Bulletin BES 08-17

Subject: Front Disc pad noise.

Vehicle Involved: 2004-2008 Ford F-150

1 st Desian

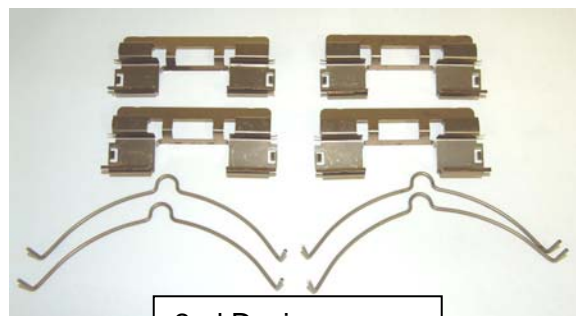
Repair Procedure: Shortly after introduction of the new 2004 brake design, Ford made a running change in the backing plate from a D1011 to a D1083. The D1083 plate has holes drilled into the upper radius that is designed to accept a pad retainer spring, which has been added to address this issue.

The new pad retainer spring (2nd design) is included in the hardware package that is included with the pads.
